SIO Shipyard Representative Bi-Weekly Progress Report		
Project: AGOR 28	Contract No.: N00014-12-C-0305	Shipyard: Dakota Creek Industries
Prepared by: Paul D. Bueren Scripps Institution of Oceanography (SIO) 297 Rosecrans St. San Diego, CA 98106	Date: January 16, 2015	Program Officer: Robert (Tim) Schnoor Office of Naval Research 875 Randolph St ONR 321 Arlington, VA 22203-1995
Distribution Statement A: Approved for public release; distribution unlimited.		Report No. A002.070

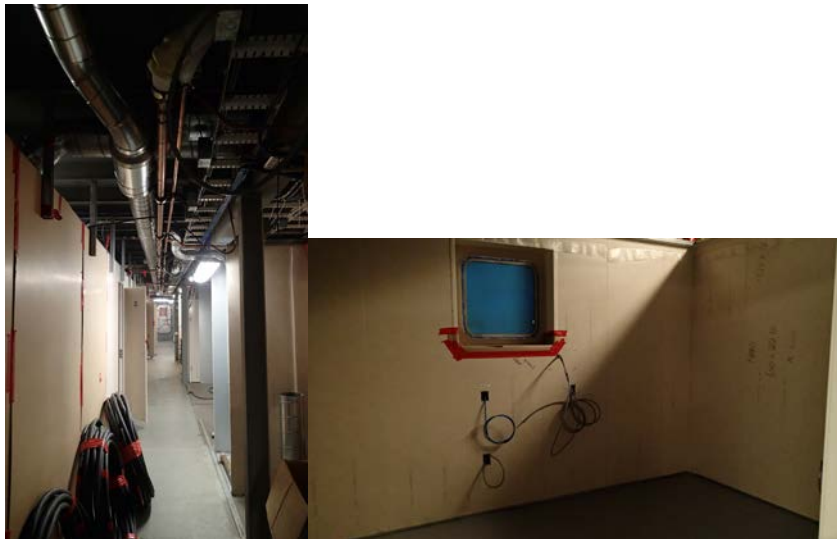
- Side & CTD Handling Systems – Unresolved issues with fairlead interferences from TK70-70 main crane remain. No changes since last reported. DCI is using Sally Ride's aft fairlead foundation to test various new locations on Armstrong. Ride's foundation was not permanently fixed so this is acceptable. The foundation was moved laterally to a position just inboard of the crane's boom and raised approximately 8-inches. This will allow the wire from the aft winch to pass aft of the cranes snout. It also appears that the forward winch will also be able to utilize this

change in configuration. No permanent changes should be made until both winches and handling devices are operational. For the fwd winch and CTD handling device, issues still remain in regards to possible interference with the crane's winch and crutch. These can best be verified once the winches and handling systems are operational. No movement on these issues since last report.
